## Addendum No. 3

**Project:** USC Hamilton College Renovation  
**Project No.:** U-651-07  
**State Permanent Improvement Project No.:** H27-9905-SG  
**Date of Issue:** May 8, 2014

Drawing No.  
**M2.3**

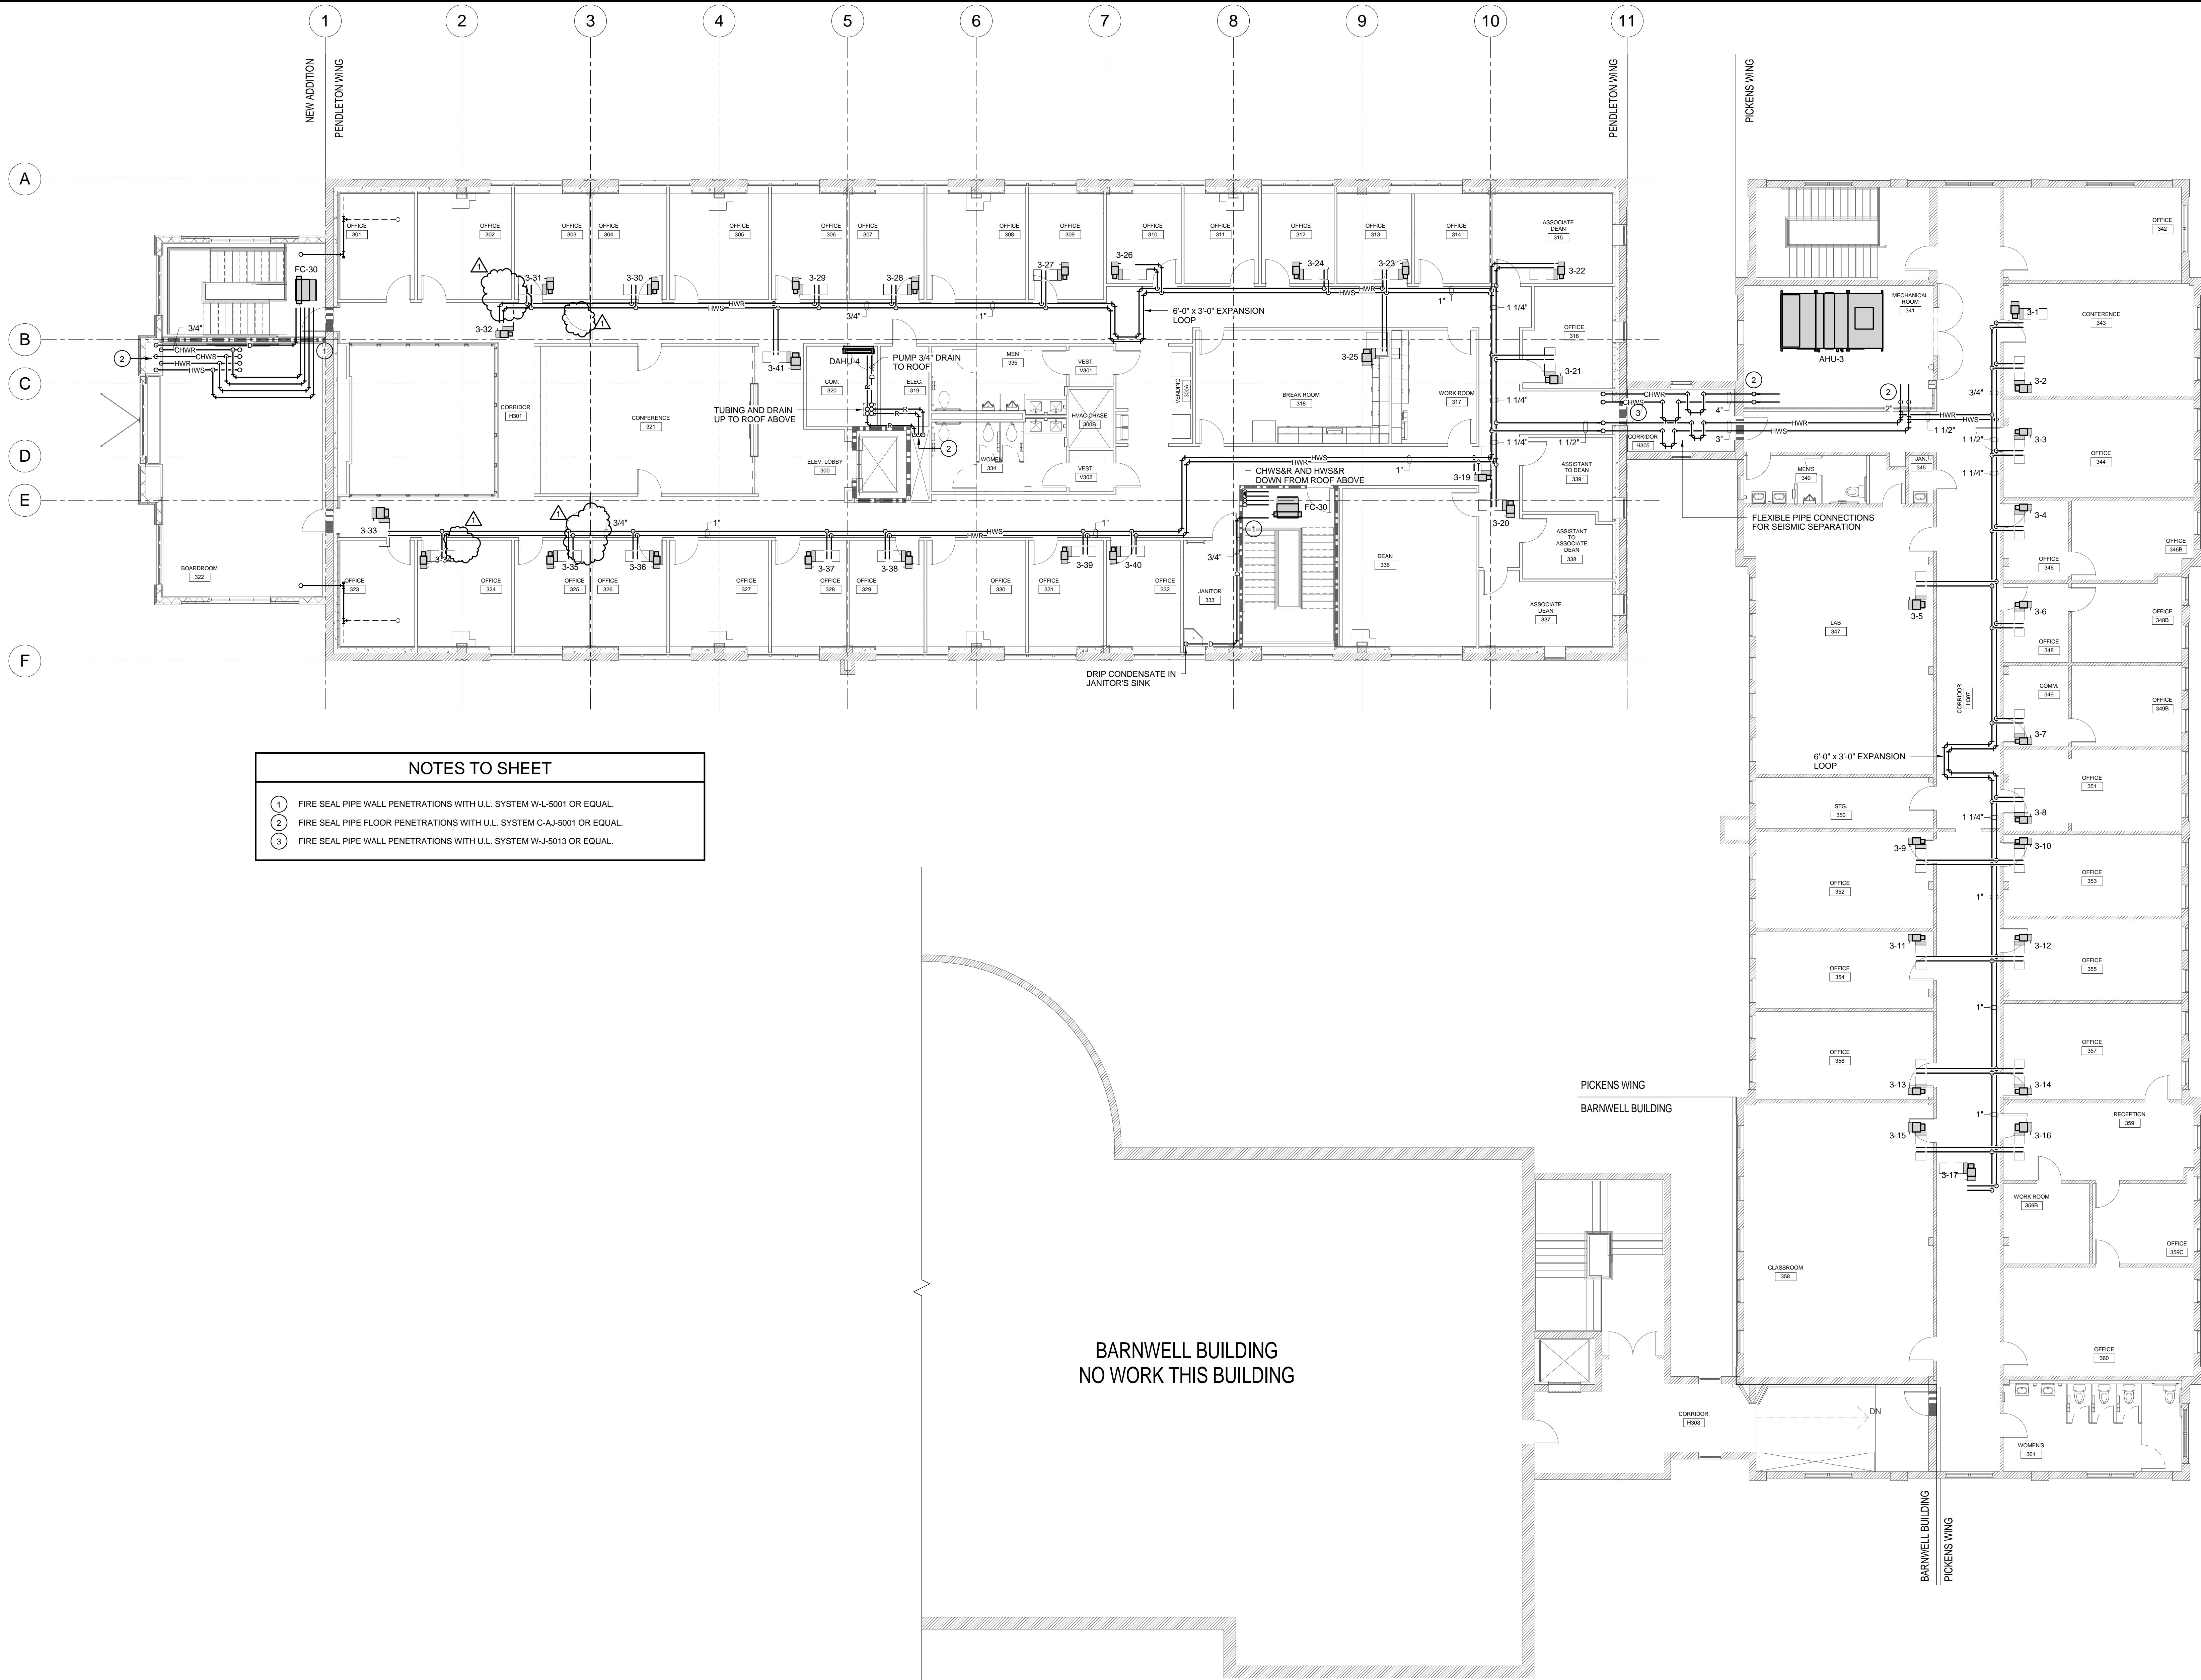
6. Sheet M1.3, Third Floor Plan – See revised drawing M1.3. This revised drawing removes the fire dampers at the Atrium where the fire rated wall is removed.
7. Sheet M2.3, Third Floor Plan - Piping – See revised drawing M2.3. This revised drawing removes the fire sealed pipe penetrations at the Atrium where the fire rated wall is removed.
8. Sheet M3.1, Piping Diagrams – Steam vent from pressure reducing stations shall be 6". Vent pipe shall be routed with in piping chase with hot and chilled water up to roof.
9. Sheet M4.2, Schedules, Legend and Details – Refer to the Legend, add symbol PF to refer to a Plaster Frame.
10. Sheet M4.3, Details – Revised drawing M4.3 adds Fan Coil Piping Diagram and VAV Heating Coil Piping Diagram.
